## **PLANNING COMMISSION MEETING STAFF REPORT**

**NAME OF PROJECT:** The Homestead Resort

**AGENDA ITEM:** The Homestead Phase 1

**Subject: Homestead Resort, Preliminary Approval Review**

HOMESTEAD RESORT | PRELIMINARY PLAN | PARKING PLAN

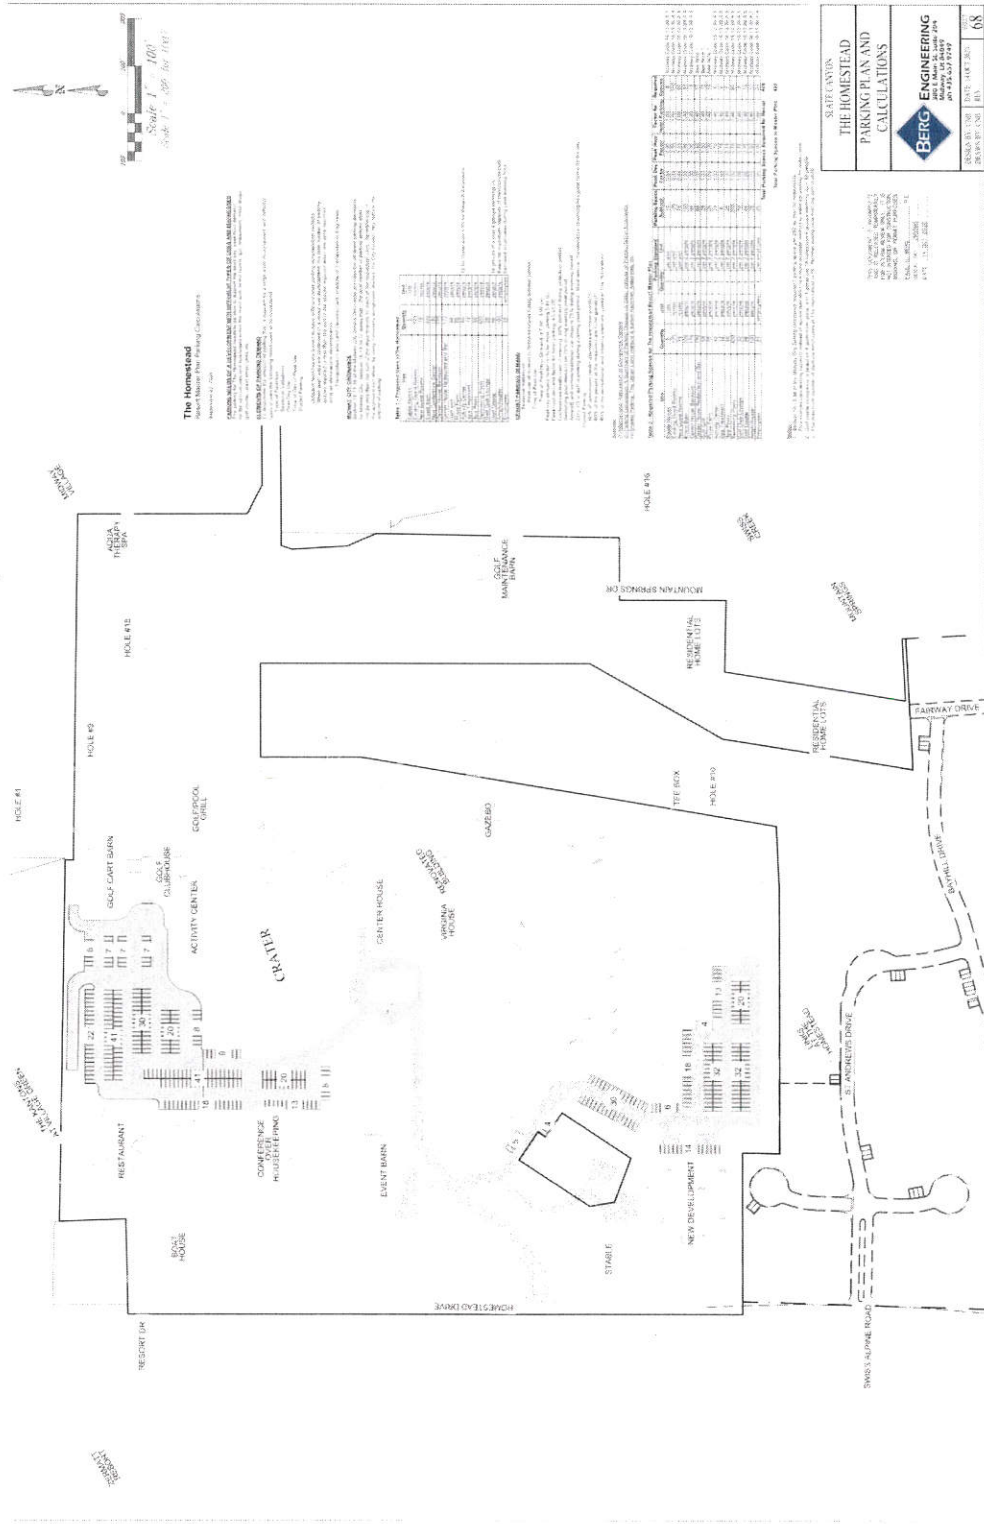
The idea behind the proposed reduction is based on nationally recognized studies for resorts. The idea is that many of the people visiting the restaurants, golf, and other amenities are those staying in the hotel rooms. There is no reason to require maximum parking for both if there is overlap. Staff has reviewed the proposal and is recommending approval but staff would like to have an overflow parking area designated on site, in a grassy area, to handle ‘perfect storm’ scenarios so parking will be located on the Homestead property and not overflow into surrounding neighborhoods and along public roads such as Homestead Drive. Please see sheet 68 for the full parking analysis.

*Southern parking lot* – A light mitigation plan must be submitted to the City that will shield the lighting from the southern parking area to the residences in The Links. The plan will mitigate this potential impact through a combination of a berm, landscaping, and a non-sight obtrusive fence that is agreeable to the City. All costs of mitigation shall be borne by the Developer.

1. An overflow parking area is designated on the plans in a grassy area so that parking does not overflow into surrounding neighborhoods and along public roads such as Homestead Drive.
